UBC Development Permit Board Meeting

Date: Wednesday, February 24, 2016

1. **That the Development Permit Board recommend that the Director, Campus and Community Planning issue a Development Permit for the market residential development on Lot 23 in Wesbrook Place Neighbourhood as detailed in the attached drawings (Attachment A), subject to the following conditions:**
 - 1) **That SC2-A.5 of the Development Handbook be relaxed for this project to permit reductions in minimum setback requirements at various locations for architectural roof and balcony projections.**

On January 7, 2016, Adera submitted a Development Permit application to Campus and Community Planning to develop a 6 storey market residential development with two levels of underground parking on Lot 23 in the Wesbrook Place Neighbourhood. The Wesbrook Neighbourhood Plan (Plan of Land Uses P-10) designates Lot 23 for up to 6 storeys of residential development with a maximum floor space ratio (FSR) of 2.8.

DRAWING TITLE:
SHADOW DIAGRAM

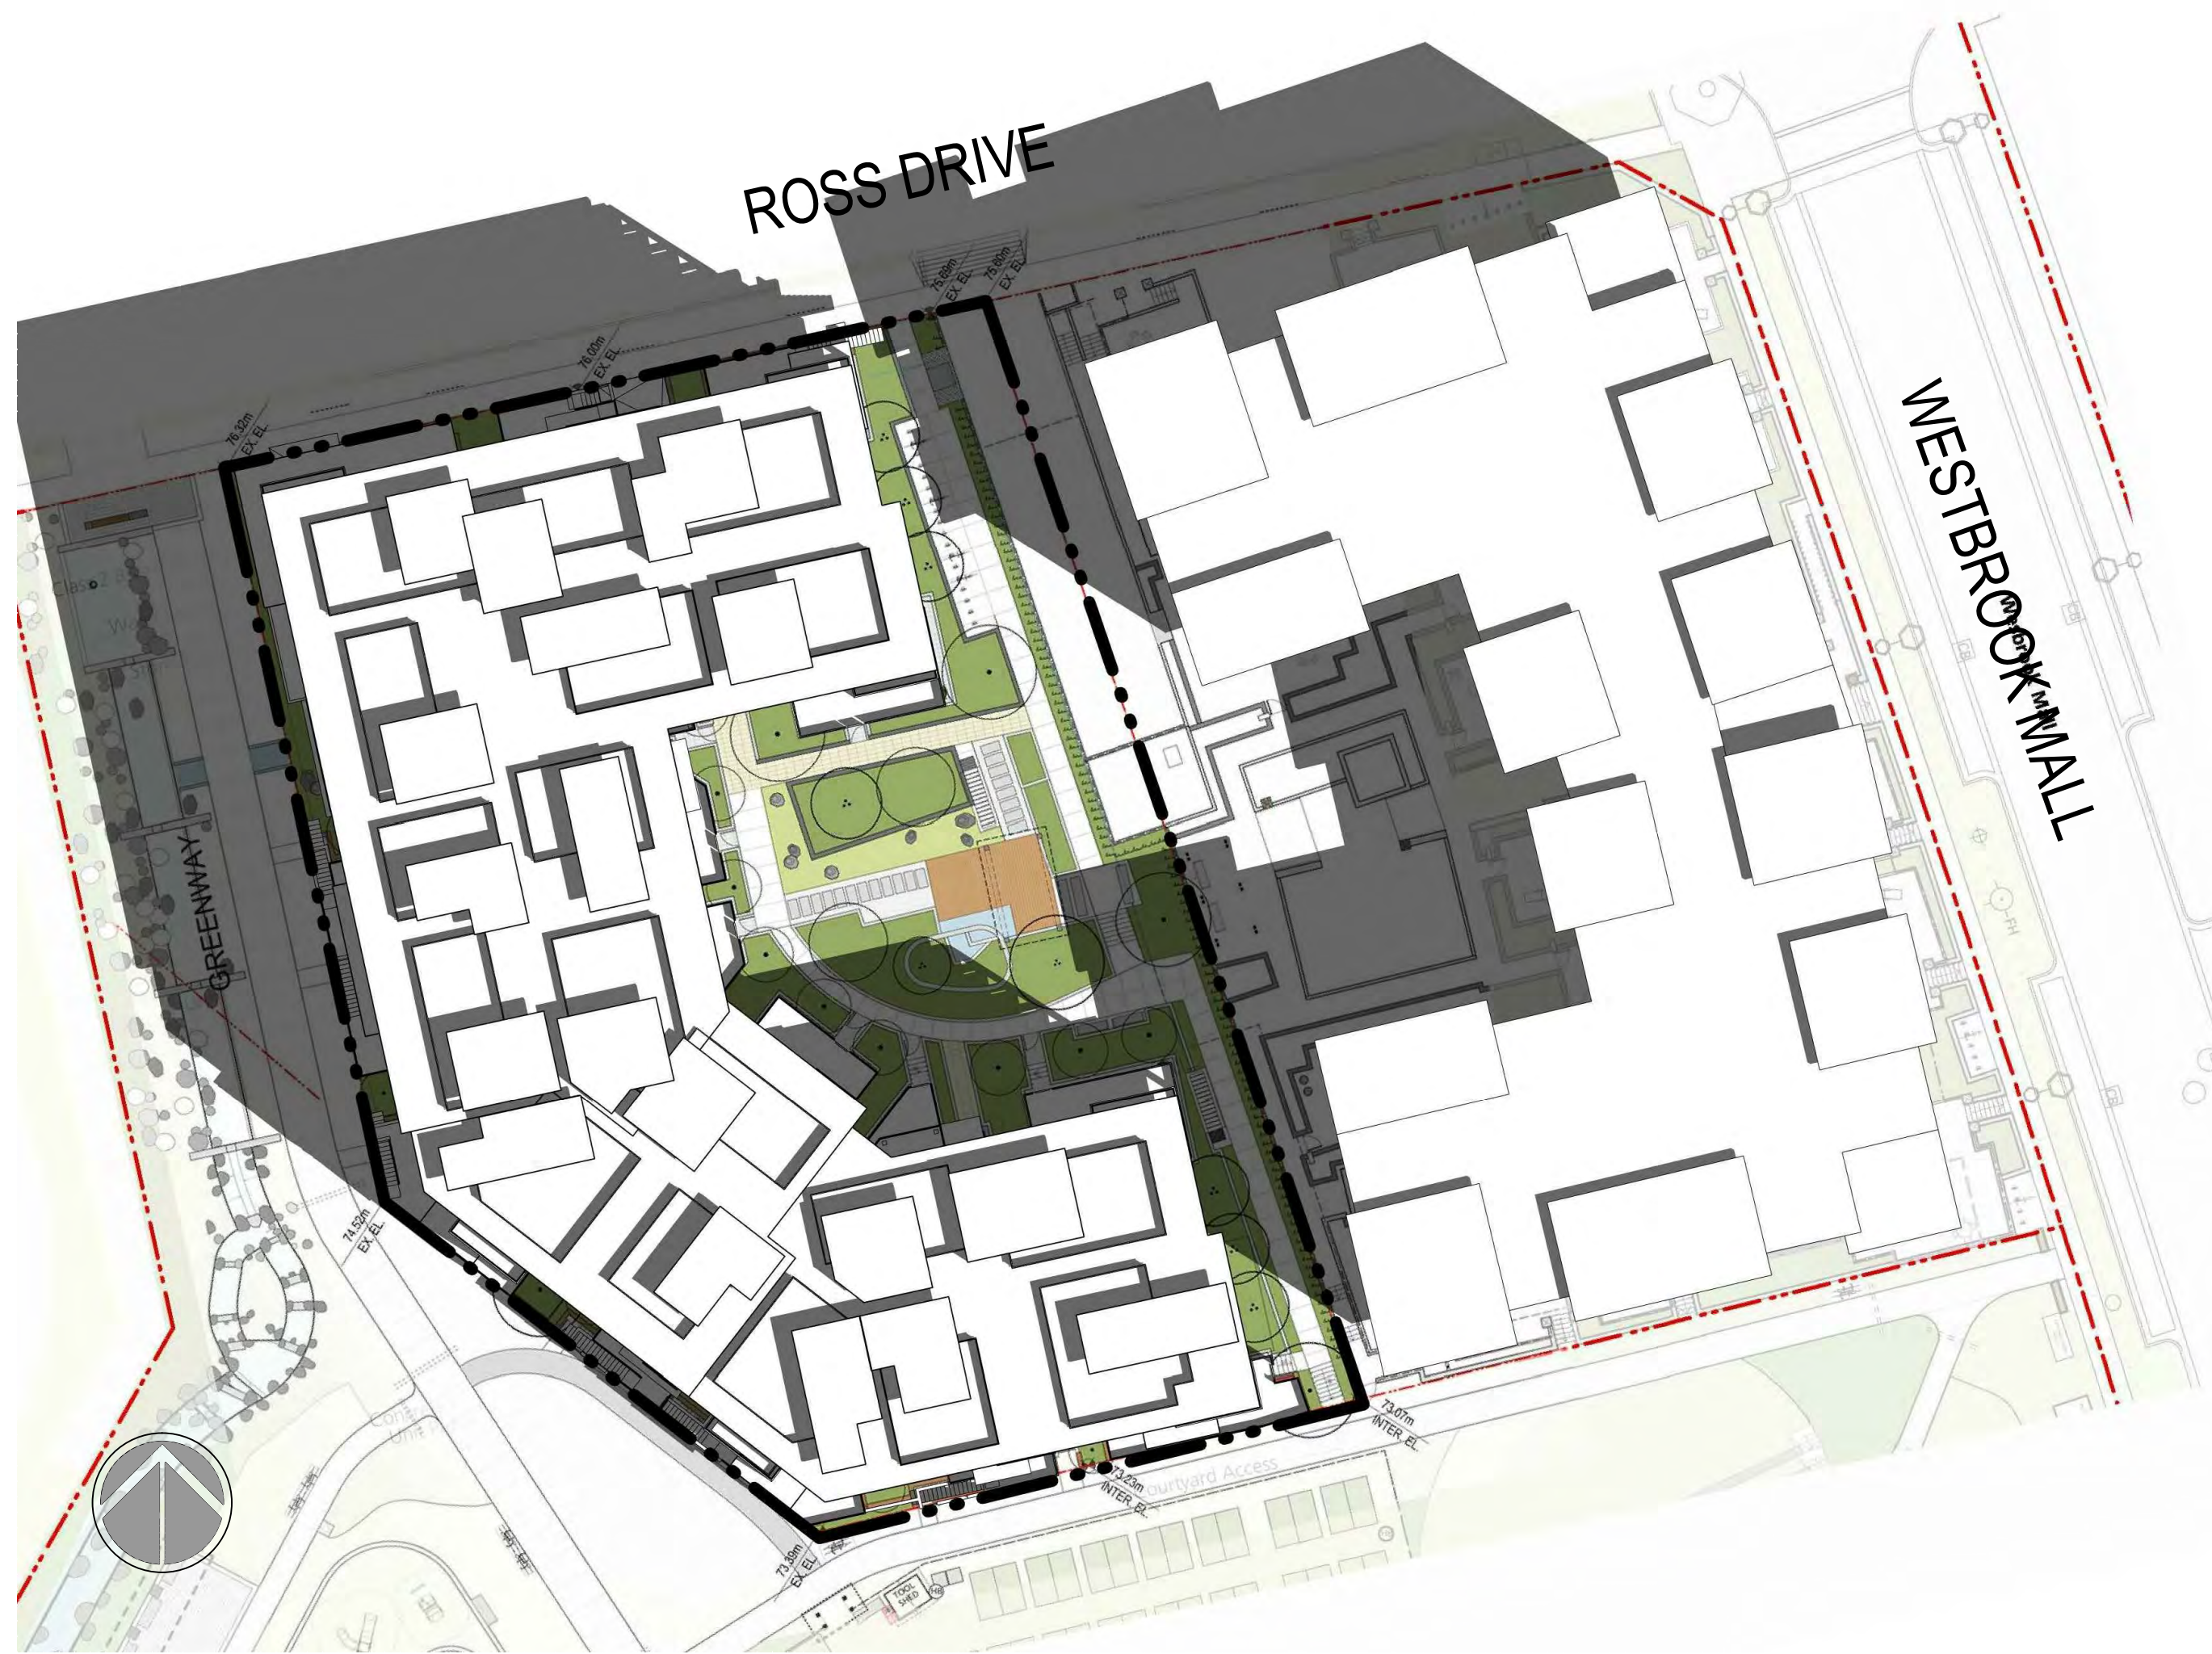
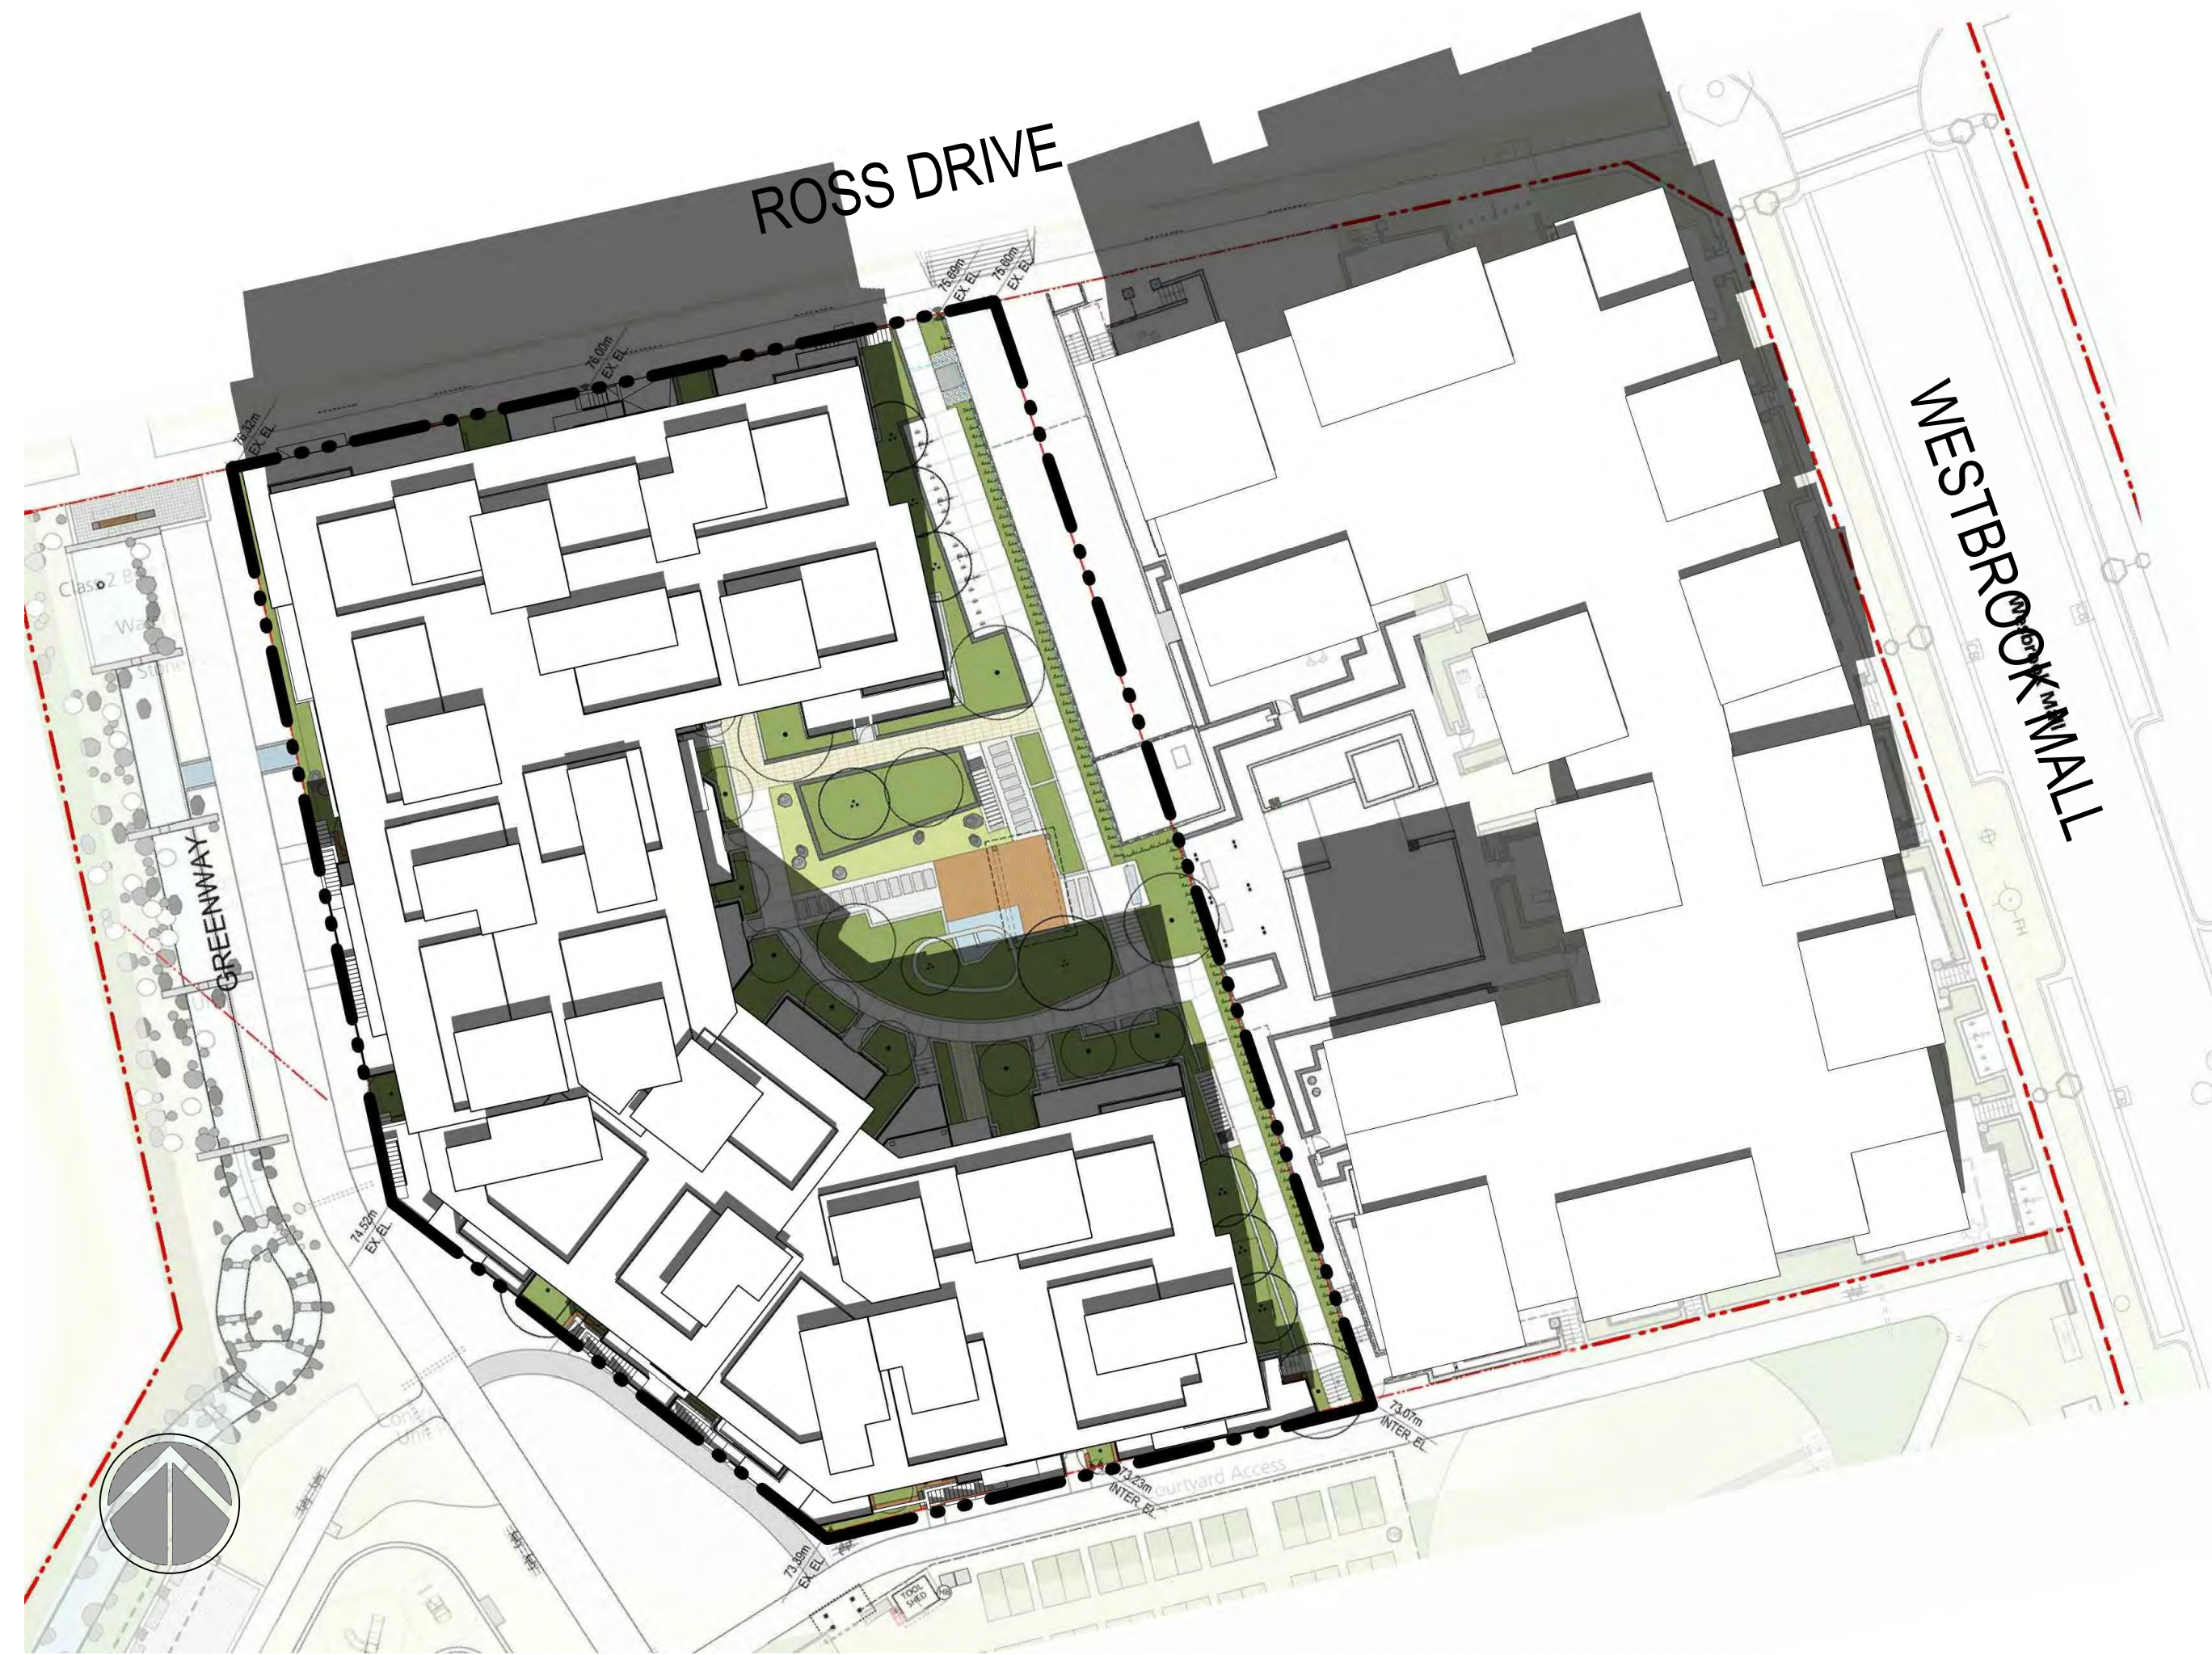
The Shadow study provided by the applicants on Sheets A6.6 and A6.7 in the plan set show the shadowing effects expected to be generated by combining the shadowing from each building on Lots 22 and 23. At the request of Campus and Community Planning, the shadowing study was expanded to include the shadows created by Nobel House as well as the new development in order to better understand cumulative impacts. In addition, shadow diagrams were prepared for four different timeslots instead of the previous three (10am, 12 noon, 2pm and 4pm).

The results of the shadow study show that while virtually all of the units in lots 22 and 23 will receive sun during the summer, portions of the courtyards will receive only partial sun. In the spring and fall, the courtyards in both projects will receive little or no sun and many of the west facing units in Nobel House will be in shade in early morning and late in the afternoon.

- **Shadow Diagrams**
- The shadow study was revised to include the shadow impacts of both Nobel House and the project buildings. The analysis was also expanded to include shadow diagrams in spring/fall and at four times of the day (10am, 12 noon, 2pm and 4pm).
